The attached letter is STP's response to 22 NRC questions on FSAR Sections 2.1, 2.2, 2.3, and 10.4. Please call me at 361-972-4610 if you have any questions.

South Texas Project
Units 3 and 4
Docket Nos. 52-012 and 52-013
Requests for Additional Information on STP 3 & 4 COLA

Attached are responses to NRC questions included in Request for Additional Information letter numbers 9, 10 R1, 11, 15, 16, 17, 18, 19, 20, 21, and 24 related to COLA Part 2, Tier 2, Sections 2.1, 2.2, 2.3, and 10.4. This submittal includes responses to the following Question numbers:

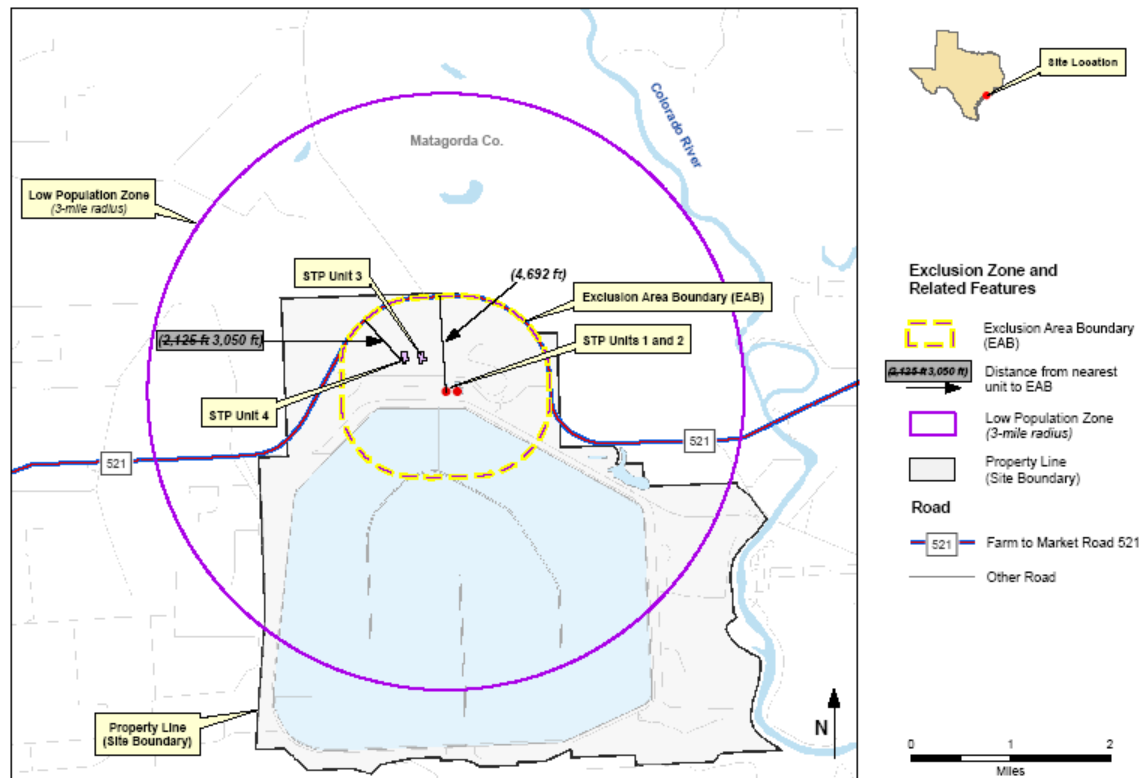
From the STP 3 and 4 FSAR Figure 2.1S-4, it is estimated that the minimum distance to EAB from Unit 4 is about 3050 ft. This value is also confirmed from the FSAR Table 2.3S-22 (Page 2.3S-96). But on the STP 3 and 4 FSAR Figure 2.1S-3, the minimum distance to EAB from unit 4 is labeled both on figure and in legend as 2125 ft. Please clarify and correct as appropriate.

FSAR Figure 2.1S-3 will be modified to reflect the actual distance (3,050 ft) from the centerline of the Unit 4 Reactor Building to the EAB as shown in Attachment 1. The 2,125 ft distance previously identified on the figure and the legend reflected the distance from any potential release point (closest edge of the power block area) to the EAB.

FIGURE 1

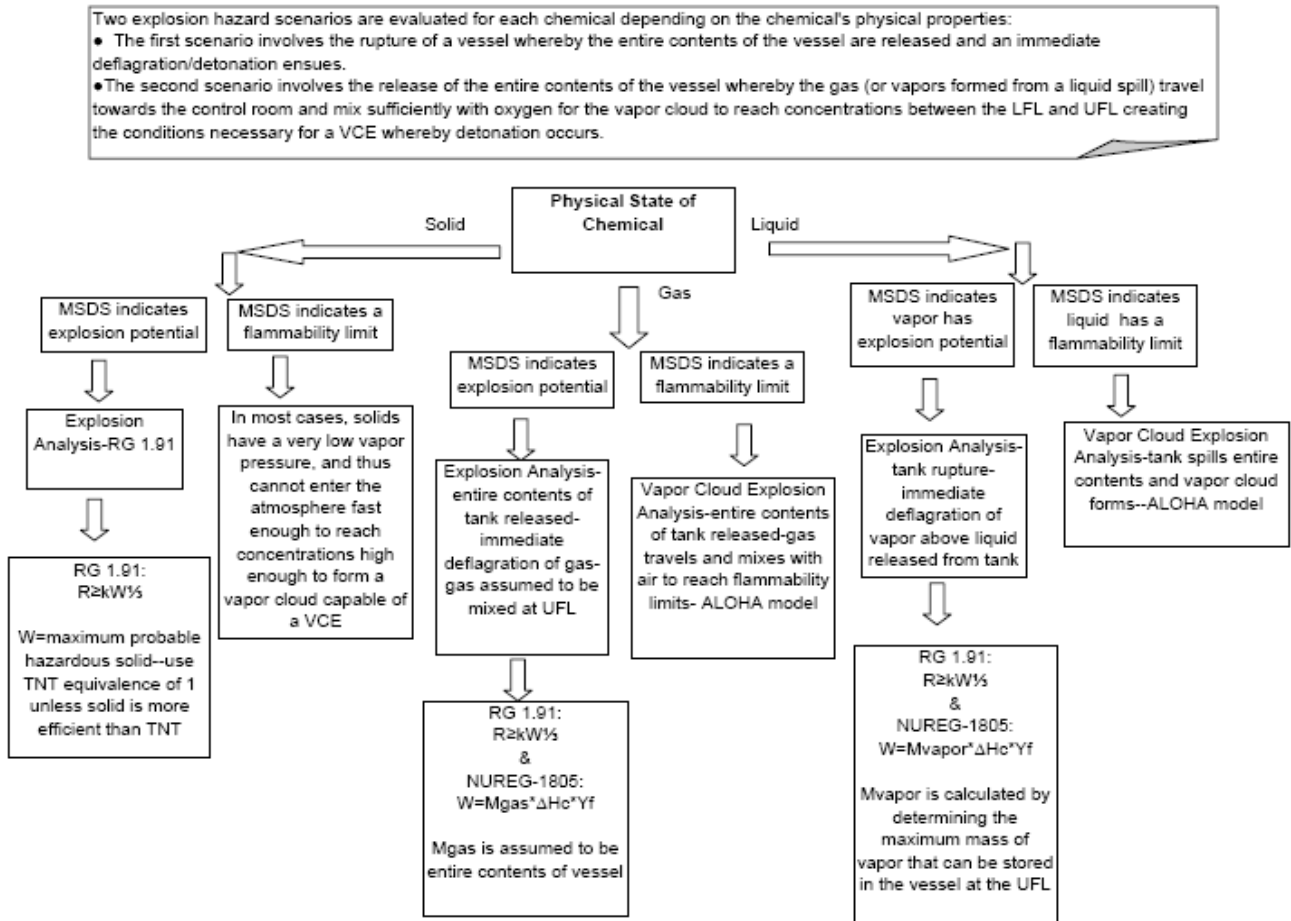
The minimum safe distance values shown in Table 2.2S-9 are said to be based on TNT equivalency method using Regulatory Guide (RG) 1.91 methodology. But they seem much smaller than generally expected. Please explain the methodology in detail.

To provide an explanation of the explosion methodology, the following new appendix to FSAR Section 2.2S will be inserted:

Figure 1

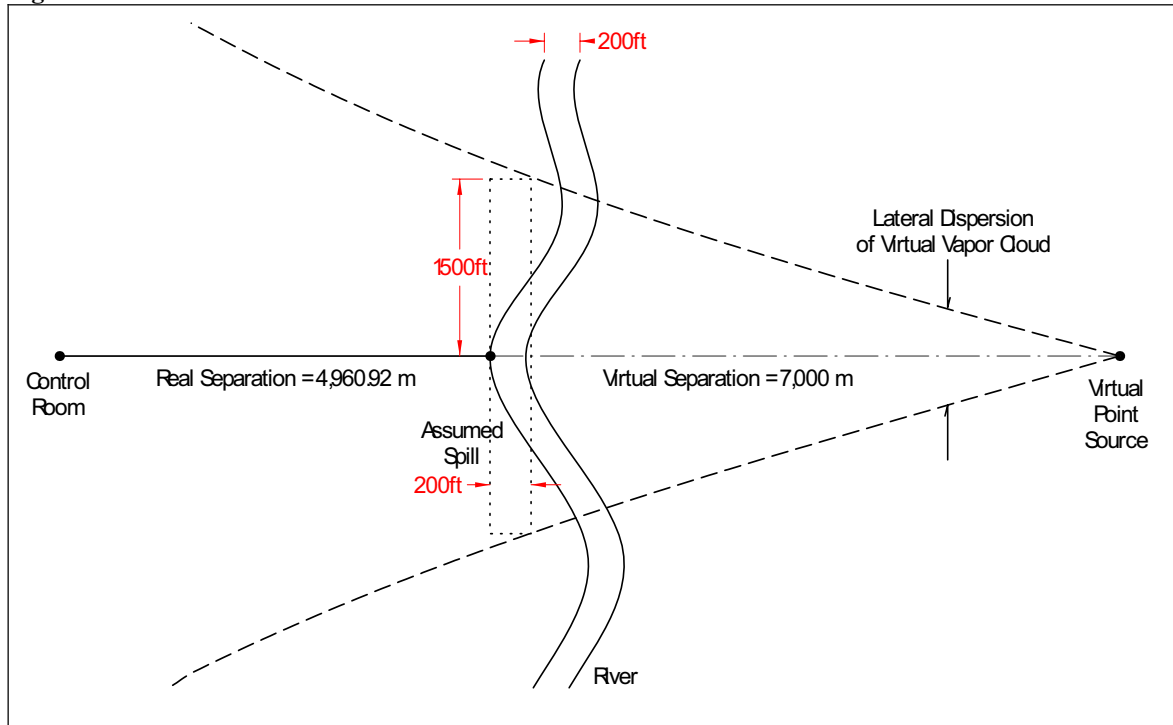
Provide sample inputs, and any assumptions made for ALOHA and DEGADIS models used in determining minimum safe distance required for an explosion to have less than one (1) psi peak incident pressure impact due to flammable vapor cloud.

This virtual distance represents the generation of a vapor cloud from a point origin that would be of an equivalent cloud size when it reaches the “real” distance at the river. (See Figure 1 below.)

FIGURE 1. Counties Considered Within the 77.91-Mile-Radius Circle

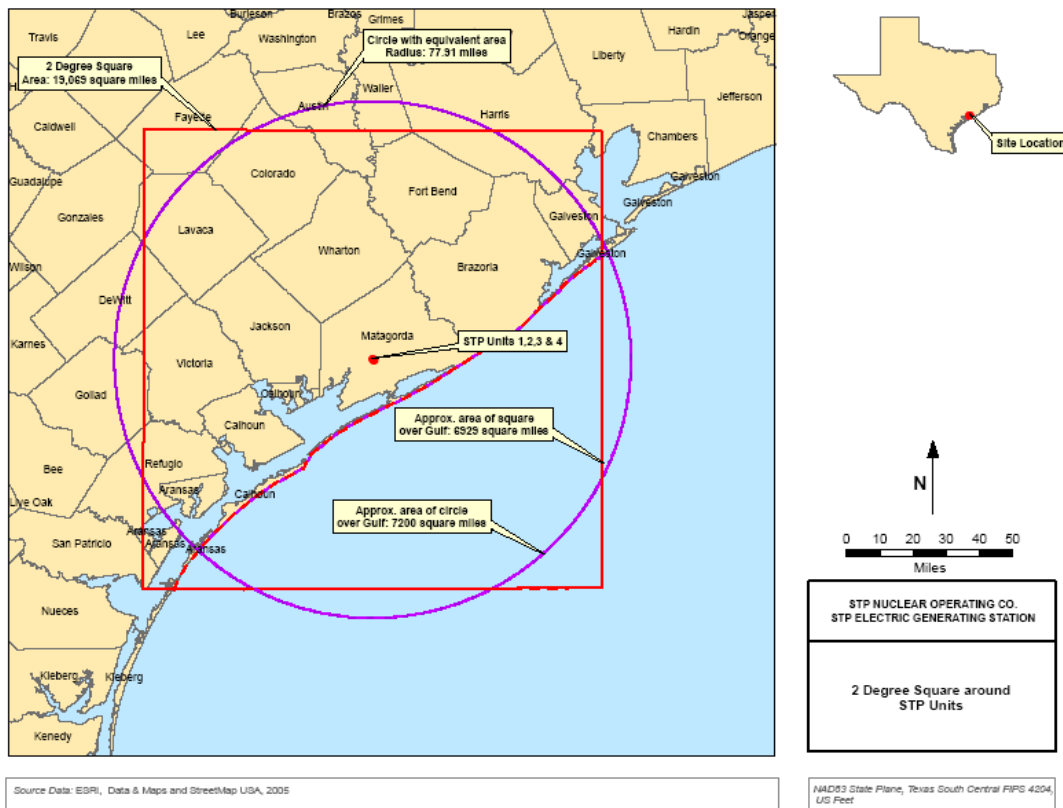
Provide statistics on the frequency of occurrence of tornadoes in the STP site region.

The STP site is located about N 28° 48' (latitude) and W 96° 3' (longitude). Figure 1 of Regulatory Guide 1.76 uses the 2° boxes to classify tornado intensity regions for the contiguous United States. As a time saving alternative to account for number of tornadoes that occurred nearby the STP site, a circular area was used in order to be equivalent to the approach used by a data retrieval application developed by the National Severe Storms Laboratory (NSSL), called Severe Plot. (<http://www.spc.noaa.gov/software/svrplot2>). As shown in Figure 1, the circle with a 77.91-mile-radius centered at the STP site covers the same area as the 2° box. To be conservative, all tornadoes were included in this analysis for counties that are either totally or partially covered by the 77.91-mile-radius circle.
